Sterling Apparels Ltd. Optimum Garments Ltd. Unicorn Sweaters

12 MARCH 2014

Executive Summary (Continued)

Highly Stressed Column

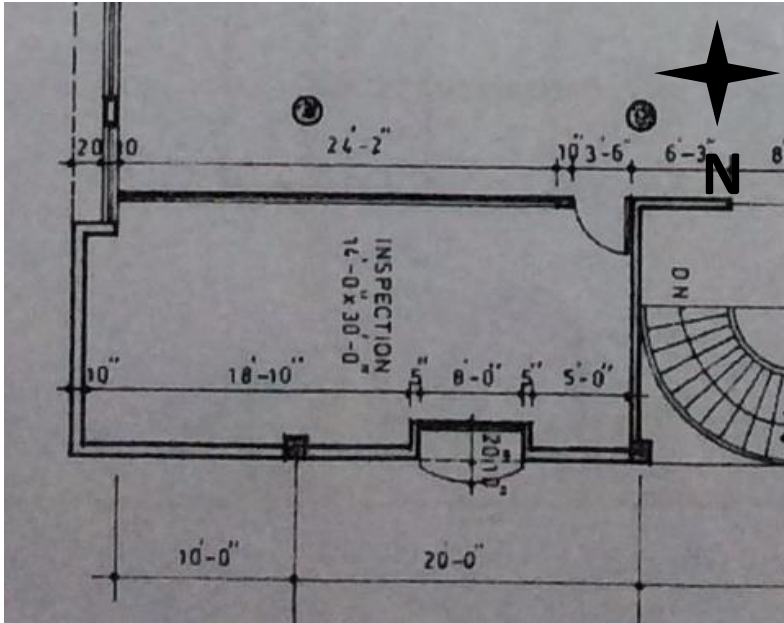
Cursory calculations indicate column working stress is at high risk level.

Engineer is to perform detailed calculations and concrete tests to prove column size and (if required):

- Reduce loads by vacating floors and removing addition structures
- Reinforce columns

Long Span Cantilever

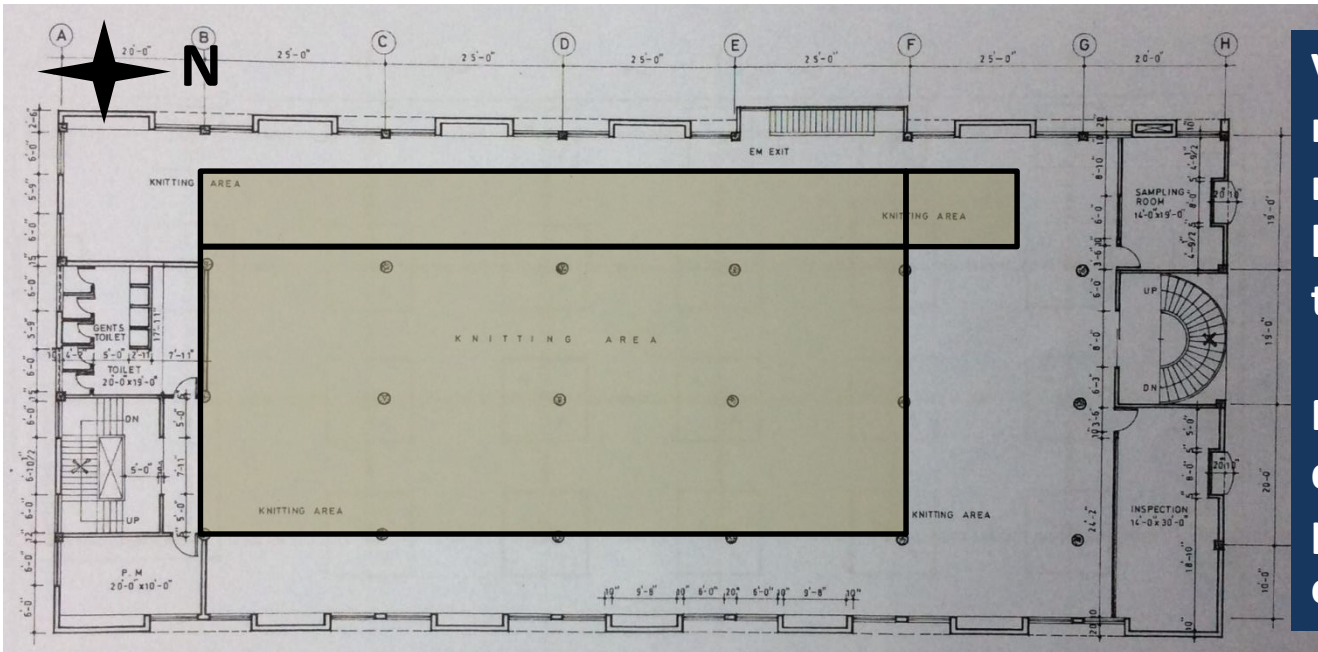
Cantilever on east façade along full length of building

Long spanning cantilever on east façade. Showing evidence of excessive deflection and distress of facades

Structural drawings show a length of 3.535m.

Numerous signs of distress are visible on walls supported on façade.

Protection for Critical Column

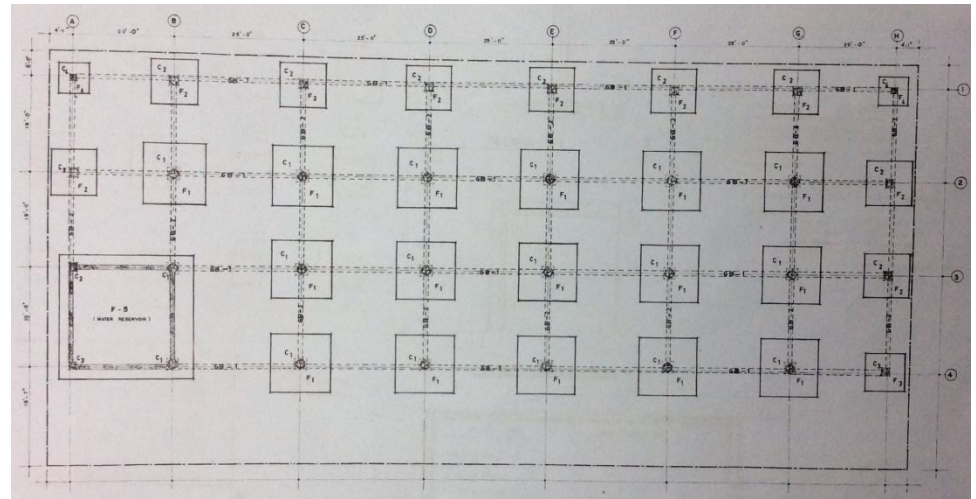
Critical element located at front of structure adjacent to truck access. Assessment of impact to column required by Building Engineer. Consider impact protection as appropriate

Soils report – Recommendation vs Constructed

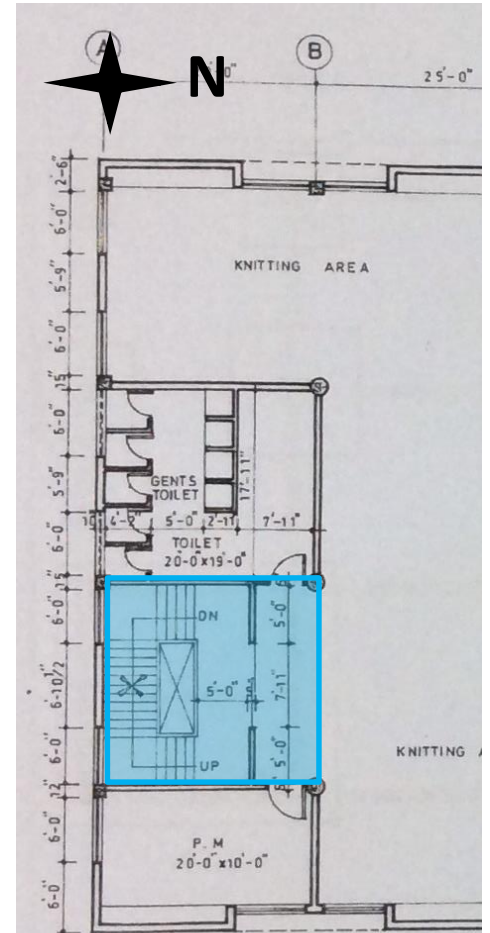
Structural drawings show that pad foundations have been used as the foundation.

According to structural information provided, pad foundation were constructed to 1.8m below existing ground level.

Assessment of adequacy of foundation needs to be assessed by Building Engineer.

Soils Report – Point d. suggests that shallow foundations are not suitable for all foundation locations.
